# State Significant Development Response to Submissions

## Site 9, Sydney Olympic Park

### Mixed use Development

Submitted to Department of Planning and Environment  
On Behalf of Ecove Group Pty Ltd

**Figure 1** – Proposed uses within the podium  
Source: Bates Smart

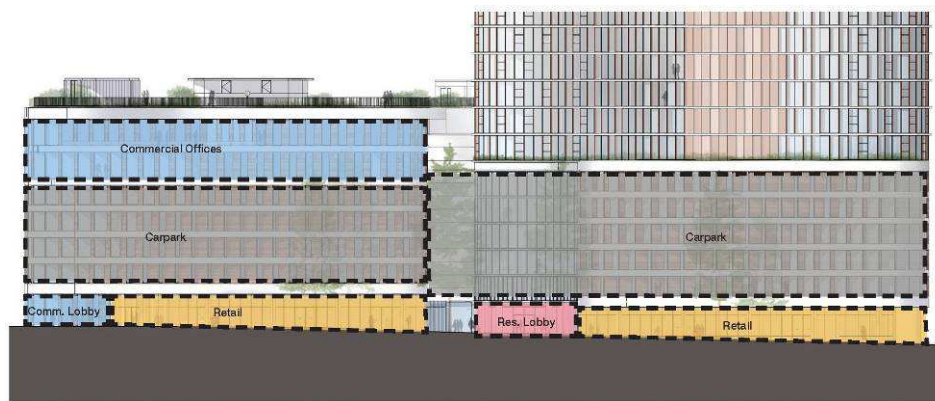
The podium has been designed as a response to the various uses as illustrated in **Figure 1**, and provides a single storey colonnade which relates to the active uses of the development at ground level. Detail sections are provided at **Figure 2** which demonstrate the following:

**Figure 2** – Sections showing originally proposed colonnade (upper), double-height colonnade with exposed carpark (middle), and now proposed increased height colonnade (lower)  
Source: Bates Smart

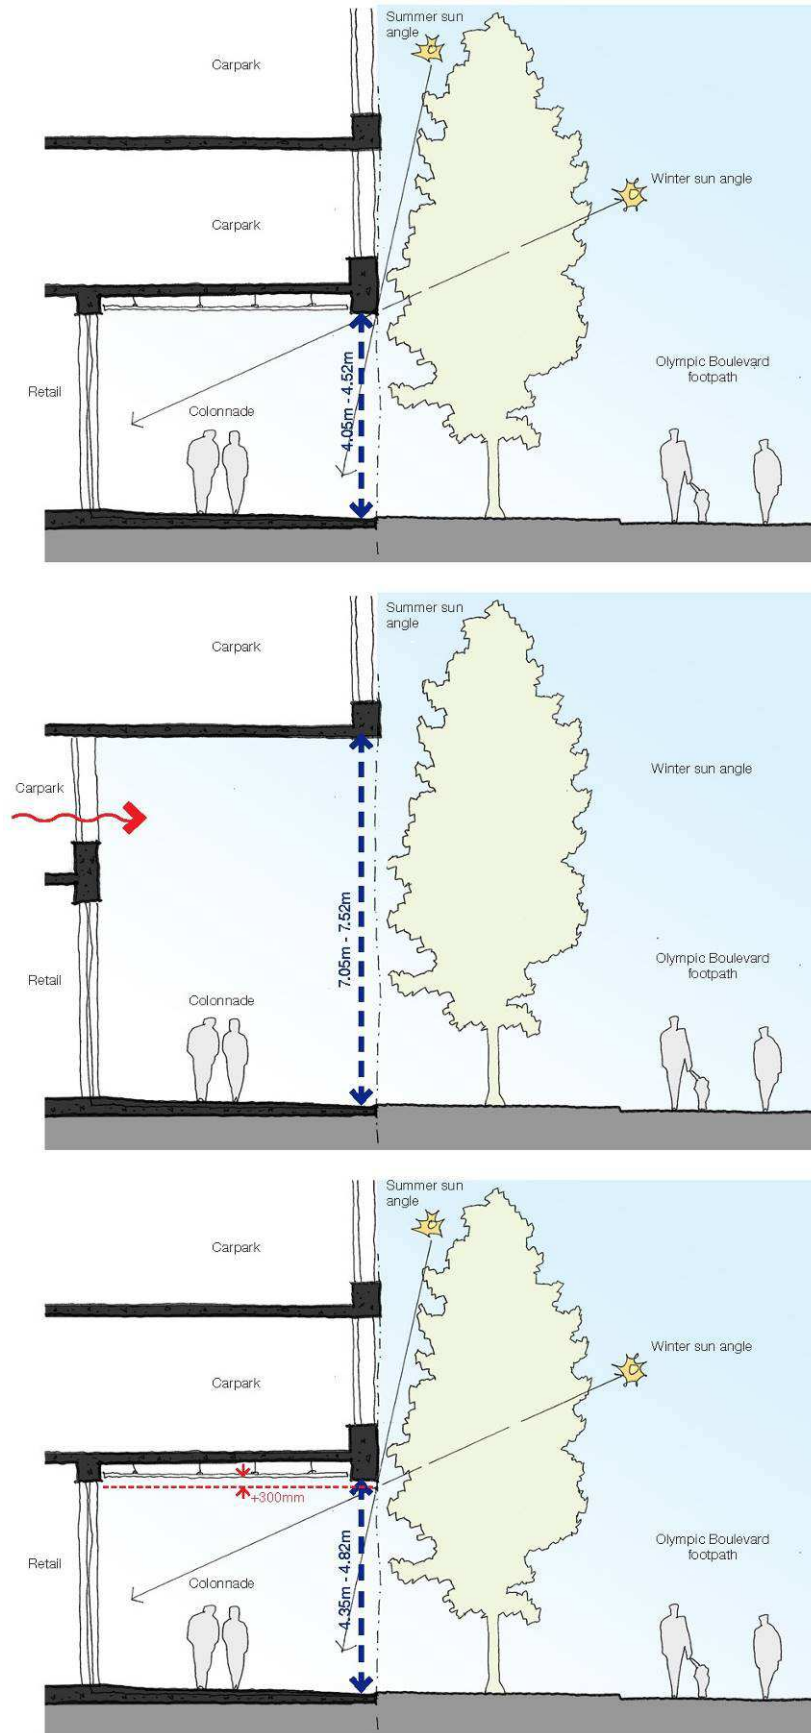
The two-storey height colonnade provides additional height to the ground level, however such a design exposes the upper level carpark facade directly to the colonnade. For this reason, it is proposed to raise the first floor level by 300mm to provide additional height along the north and south colonnades whilst minimising impact on the carpark podium design and exposure. **Figures 3** and **4** illustrate the height of the colonnade as originally submitted and now proposed.

- the current colonnade design and height provisions
- consideration of a two-storey height colonnade
- revised colonnade heights achieved by raising the first floor level by 300mm (and subsequent building levels) to provide additional height along the colonnade

**Figure 6** – Amended ground floor plan  
Source: Bates Smart

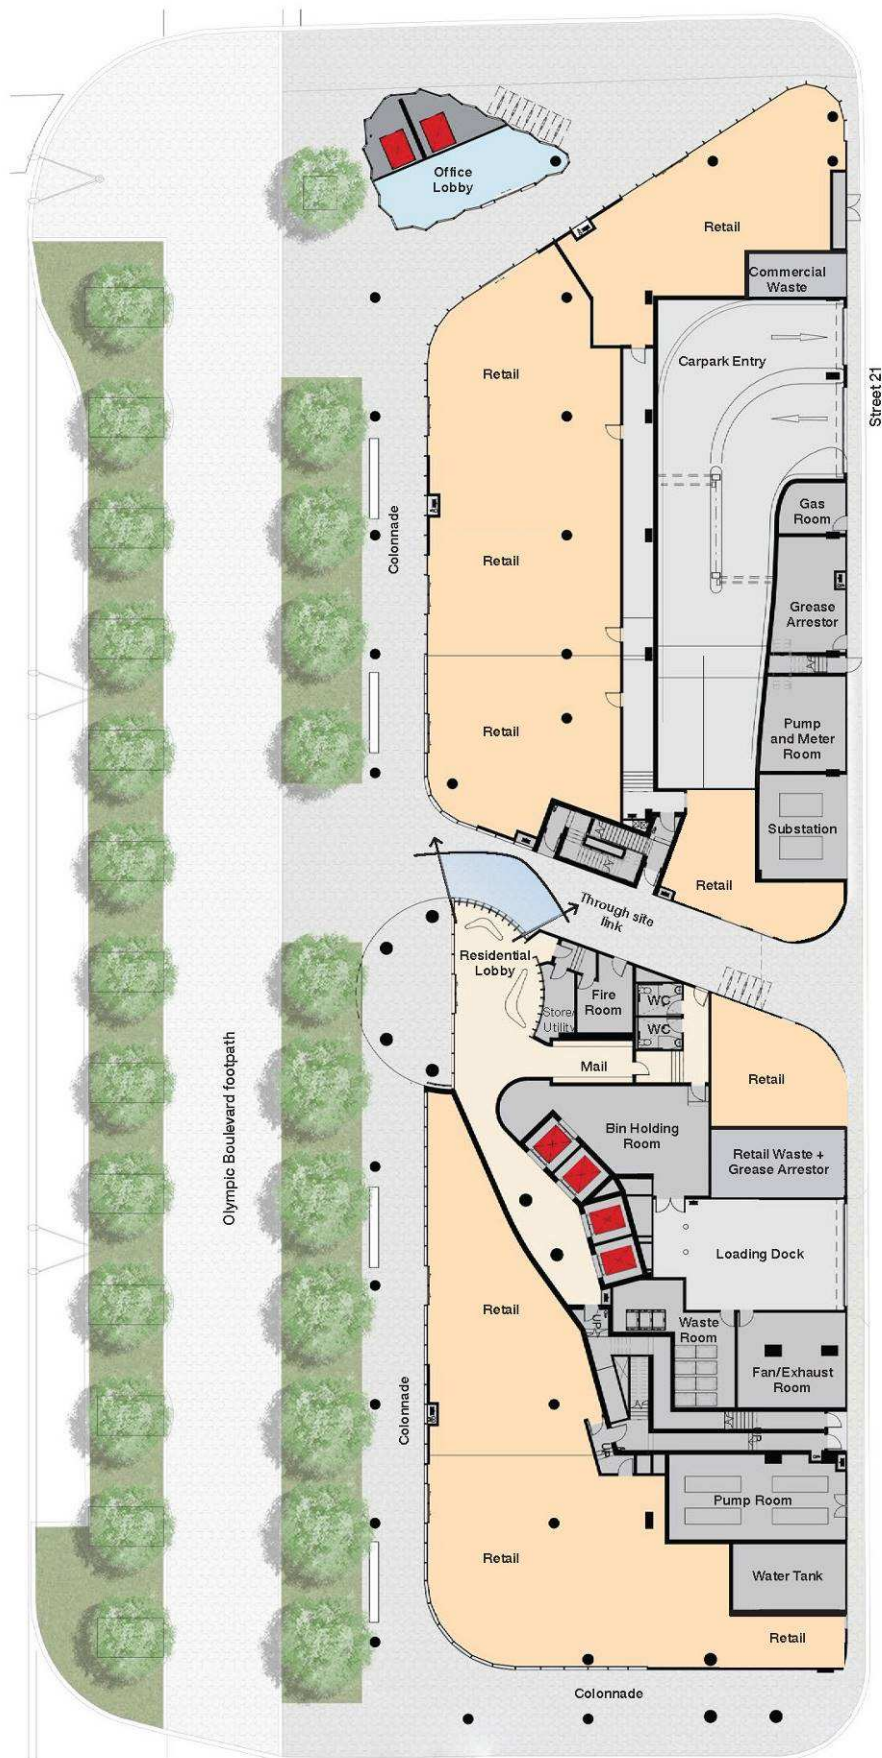
The proposed increase in the Ground Floor floor to ceiling height to improve the proportions of the colonnade also results in an increased height for the through site link. The proposed width of the link has also been reviewed, and it is noted that the 5.4m proposed exceeds the width of 4.5m recommended by the Site 9 Development Guidelines. The proposed width will permit clear pedestrian thoroughfare, and it is noted that casual bicycle parking has been relocated out of the link. An indicative montage of the link, illustrating the proposed proportions, is provided at **Figure 5**.

Further to these measures, the design of the through site link and adjoining building has been refined to further increase activation (refer **Figure 6**). Additional retail / commercial tenancies are provided at the eastern corners of the site link, which will provide additional activation to the link. The bicycle storage and plant have been relocated. (The bicycle storage will be relocated to Level 9 of the tower, requiring the deletion of one apartment on this level).

**Figure 7** – Views of proposed cut-through link and commercial lobby  
Source: Bates Smart

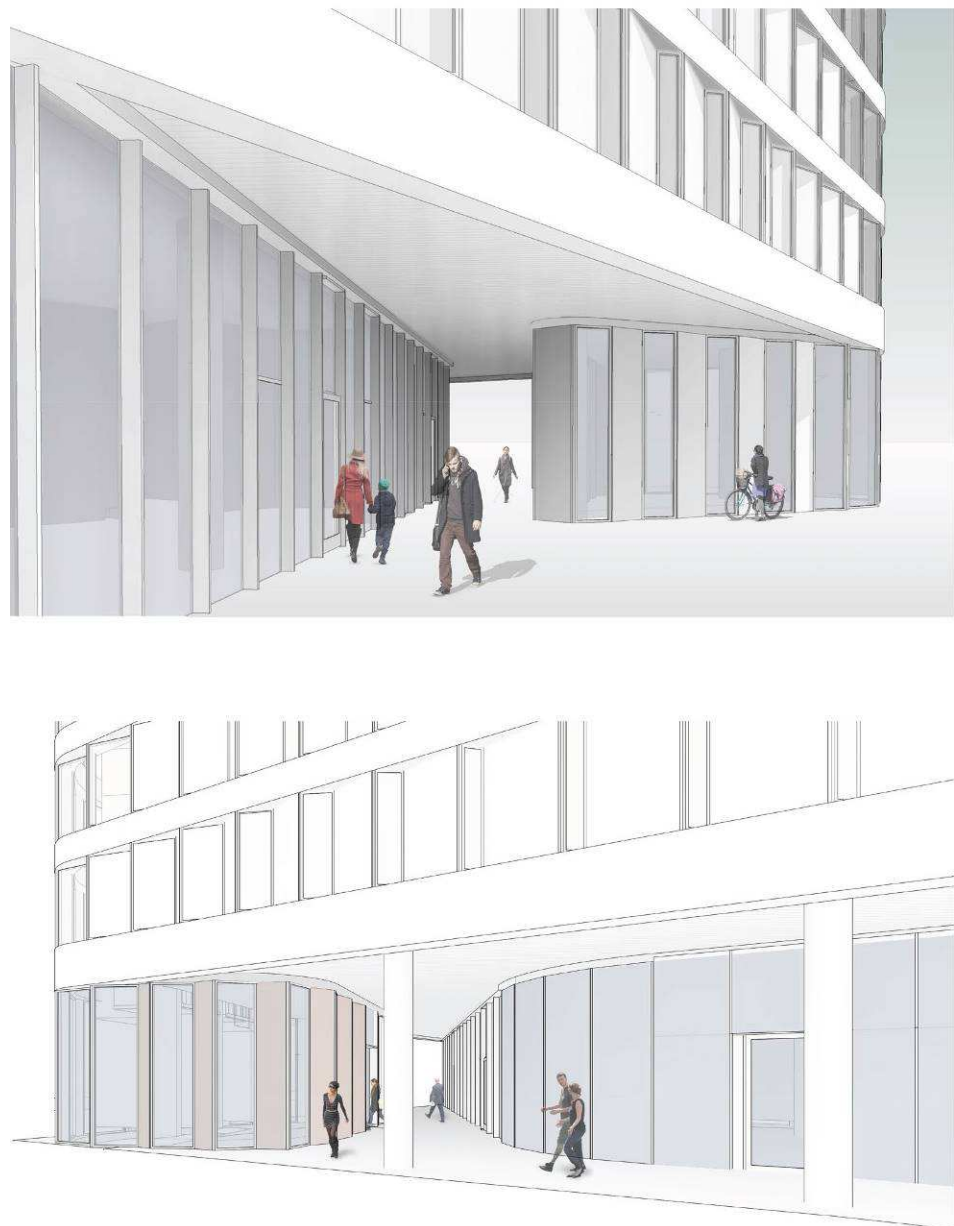
**Figure 7** shows two perspectives through the corner cut-through link as viewed from Sarah Durack Avenue and Olympic Boulevard. The link is directly flanked by a series of glazed retail tenancy entries and a glazed commercial lift lobby entry on both sides, providing both active use of the space as well as passive surveillance.

Its proximity to Sarah Durack Avenue and Olympic Boulevard as well as the proposed visitor bicycle parking directly adjacent also serve to provide activation and passive surveillance. The structural column has been designed to sit within the commercial lift lobby so as to ensure no hiding places at this junction.

The commercial lobby and retail tenancies will have CCTV facilities which will overlook the cut-through link, and lighting will be integrated into the colonnade ceiling design to further enhance safety and security.

**Figure 14** – Illustration of building bulk shifted from southern elevation to the top of the building, ensuring all apartments enjoy excellent amenity  
Source: Bates Smart

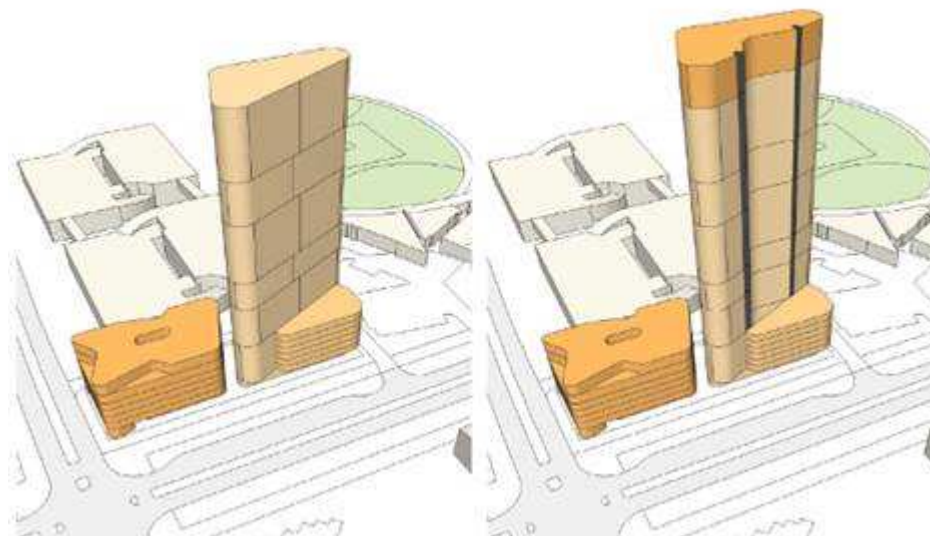
The proposed development has been specifically designed to achieve a high quality built form that is compatible with the envisaged built form of the locality. The tall, narrow tower form allows 100% of the proposed apartments to achieve solar access. This is a significant achievement for a residential tower, and was only achieved by sacrificing the efficiency of the floor plate. If the apartments were rearranged to locate a dwelling on the southern side of the core, the floor plate would be more efficient and the Apartment Design Guideline target of 70% solar access would likely still be achieved. However, the resultant building would not have the same architectural elegance, and would not achieve 100% solar access. To achieve this high standard of design and amenity, the proponent is willing to forego the economic benefit resulting from a more efficient floor plate.

It should also be noted that the additional apartment on Level 39 does not represent an increase in yield, but rather replaces an apartment at Level 9 which has been converted to residential bicycle parking.
